PRESENTATION TO THE INDEPENDENT PLANNING COMMISSION RE GREENWICH HOSPITAL RE DEVELOPMENT, SSD - 8699

Susan Ingham

15 October, 2020.

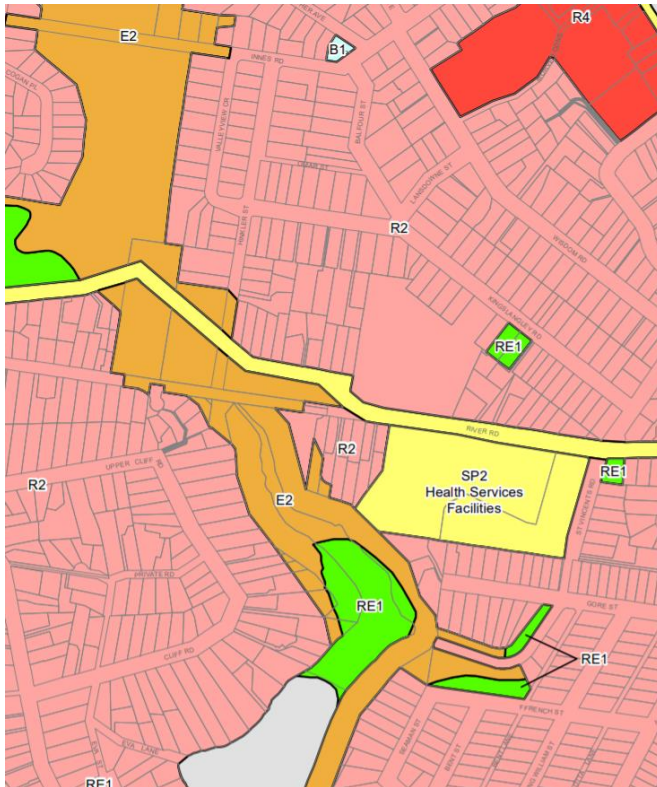
Despite HammondCare maintaining that their Senior Living Accommodation will be different, it is now the fourth facility of a similar nature being proposed for development along a short distance of River Road. There are development applications for aged care facilities at 266 Longueville Road, 4 Northwood Road and 33 Greenwich Road - these are individual addresses for what is collectively known as River Road.

The approval of HammondCare's application should be subject to the condition that the Seniors Living units would not be strata subdivided for individual sale in the future if their

Point 2: Discrepancies in the depictions of the same area of the site and inaccuracies in the contours:

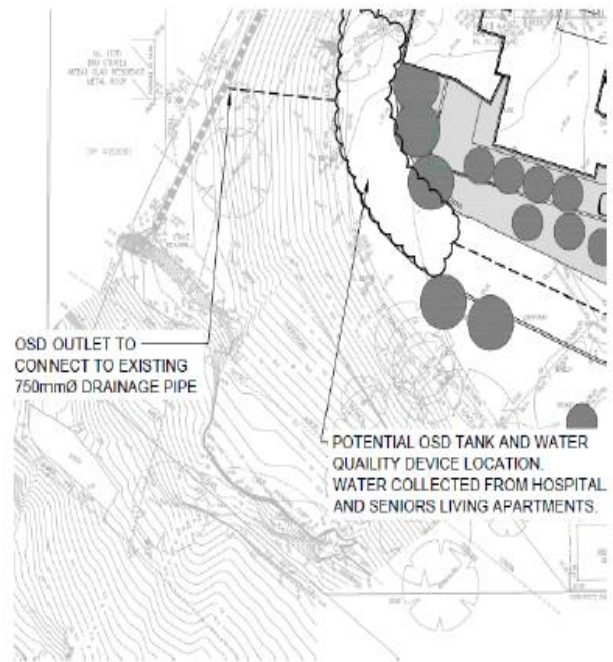
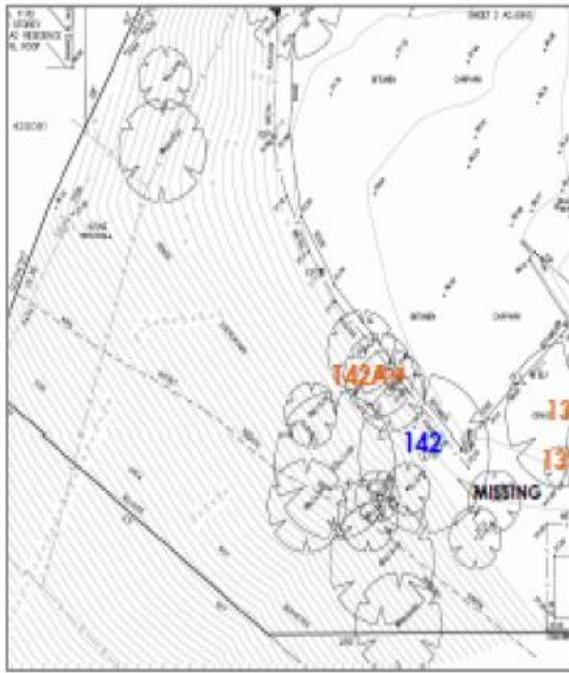
This has not been sufficiently surveyed according to diagrams provided. There are discrepancies in the depictions of the same area of the site: inaccuracies in the contours and bushland and trees in the South West corner have been overlooked. (Note P58 of the Arborist’s report, the EIS and the Landscape Plan and the differences in topography and vegetation between them.)

L: Extract p58 of the Arborist Report shows ‘interpolated’ contours, “Area Not Surveyed”, an absence of detail and ignores most existing trees.
 R: The Civil Engineering Plan accurately shows the details of contours.

L: South & S-West Boundaries, site Bushland;
 R: Omission by Arborist, Surveyor, Landscaper of a large number of trees and the landforms.

Calculating Distance of Root Spread for Trees

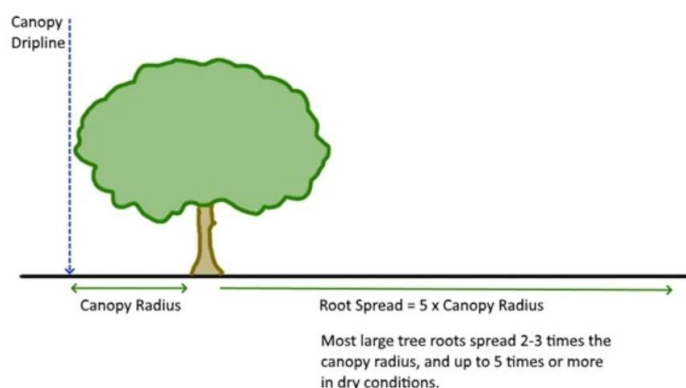
The approved design needs to demonstrate that basement and sub-soil structures will not impact the root zones and endanger existing trees, particularly heritage trees near Pallister House. This requires that the basement construction proposed near the heritage building should be at least two times the radius from the drip line, or more for large trees.
